Energy & compliance case-study review report

San Francisco Office Energy & Compliance · pack sf-office-compliance-r1 · prepared 2026-10-25 from preserved evidence only (nothing re-simulated) · Hexanta

STATUS: NOT COMPLIANT / NOT ACCEPTED. Both native Title 24 2025 performance runs were rejected on engineering review (decisions D-CX-24, D-CX-25, D-CX-28). The official Title 24 compliance report (PRF-01) was not generated. The ASHRAE 90.1-2019 PRM was blocked by expiry of the IESVE trial licence on 2026-10-25. No Title 24 certification, compliance pass, LEED result or engineer approval is claimed. Engineering approval: OUTSTANDING.

2. Native Title 24 2025 performance runs

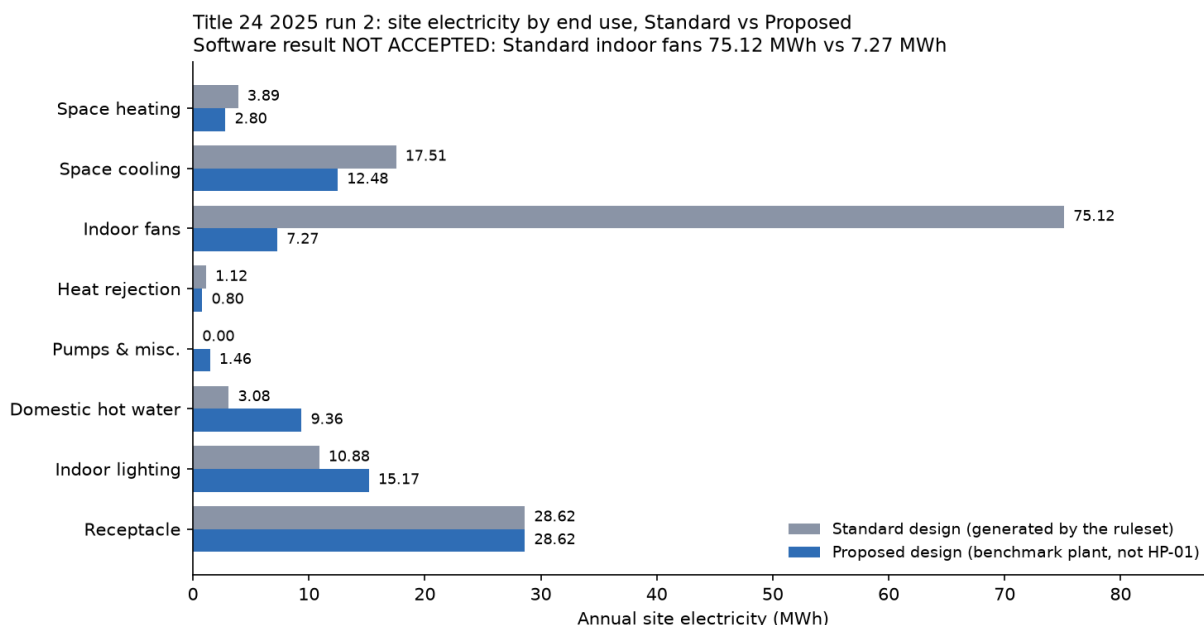
Item	Run 1 (2026-10-24)	Run 2, corrected (2026-10-25)
Software statement	"DOES comply"	"DOES comply"
Efficiency LSC margin	64.82 %	59.95 %
Source energy margin	72.17 %	68.55 %
Standard indoor fans (MWh)	81.13	75.12
Standard unmet heating hours	151	21 (Results Summary) / 24 (plausibility check) — difference unexplained
Proposed plant	library water-cooled chiller (not HP-01), autosized	code-minimum air-to-water heat pump BENCHMARK (not HP-01)
Engineering verdict	NOT ACCEPTED (D-CX-24); superseded	NOT ACCEPTED (D-CX-25, D-CX-28)

Run 2 was corrected by treating the unserved plantroom as unoccupied (Standard unmet heating hours 152 → 21), by replacing the chiller with a code-minimum benchmark heat pump, and by regenerating the Standard design with the ruleset. Automated plausibility triggers still fired: Standard fan EUI 86.9 kWh/m²·yr (trigger 40), Standard/Proposed fan ratio 10.34 (trigger 3), fans 75 % of the site-energy margin (trigger 60 %). **94.5 % of the LSC margin (44.53 of 47.11 \$/ft²·yr) is Standard fan energy; without it the margin would be about 3 %.** The corrected models therefore do not substantiate the software result.

3. Run 2 end uses (site, from the native Results Summary)

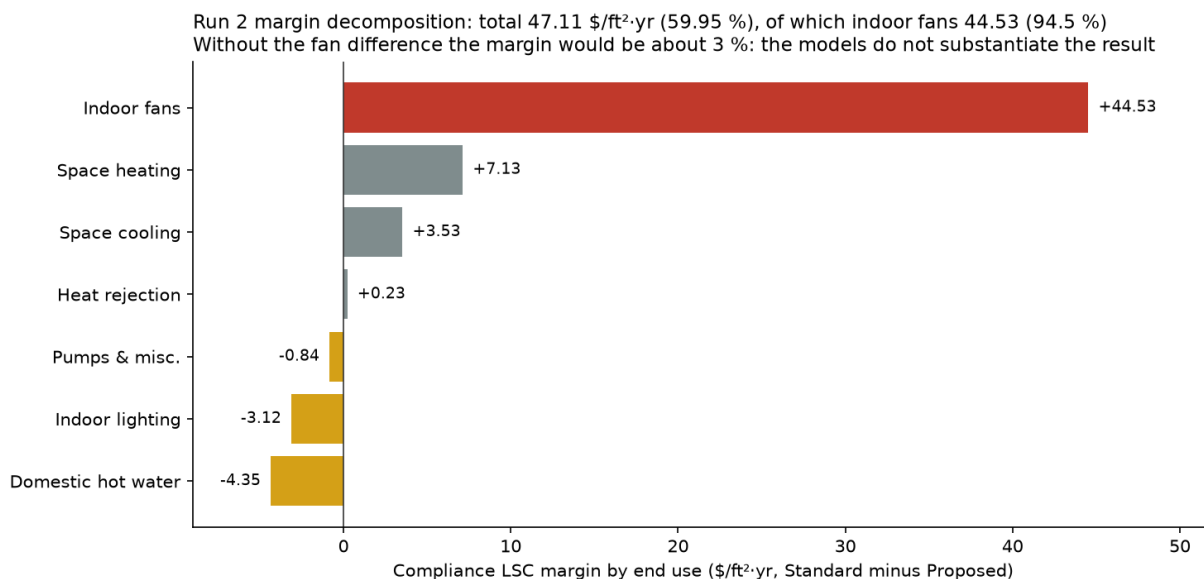
Efficiency LSC 78.58 → 31.47 \$/ft²·yr; source energy 44.79 → 14.09 kBtu/ft²·yr. Proposed site EUI 90.2 kWh/m²·yr (77.95 MWh / 864 m²) — not accepted.

Source: native IESVE 2026 Title 24 2025 Results Summary, run 2 (2026-10-25), evidence compliance-NATIVE-T24-RUN2-20261025. NOT ACCEPTED (D-CX-25, D-CX-28).

5. Hexanta offline study (r4) — PRELIMINARY

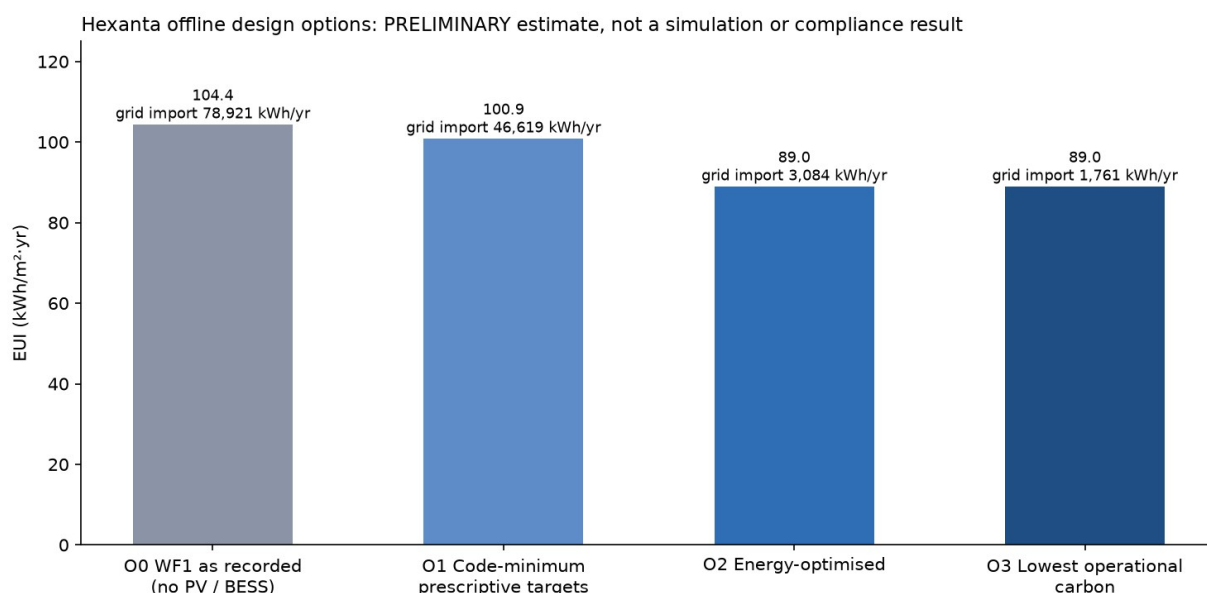
Prescriptive pre-check: **failed_precheck** (fenestration solar heat gain; installed lighting 9,864 W vs 5,480 W allowed; no PV; no battery). Passes: wall U-factor, window-to-wall ratio 37.65 %, west 40.0 %, system type. Many items blocked for missing design data. Title 24 §140.10 sizing: PV ≥ 21.076 kWdc; battery ≥ 37.522 kWh / 9.381 kW. San Francisco all-electric and energy-budget checks, ASHRAE PRM and LEED: blocked. QA 15/15 PASS (software and arithmetic checks only).

Quasi-steady hourly estimate; fans at Title 24 limits as design targets; pumps and DHW unresolved; annual-average grid carbon factor. Cost-optimised and LEED-oriented options blocked (no prices, no PRM results).
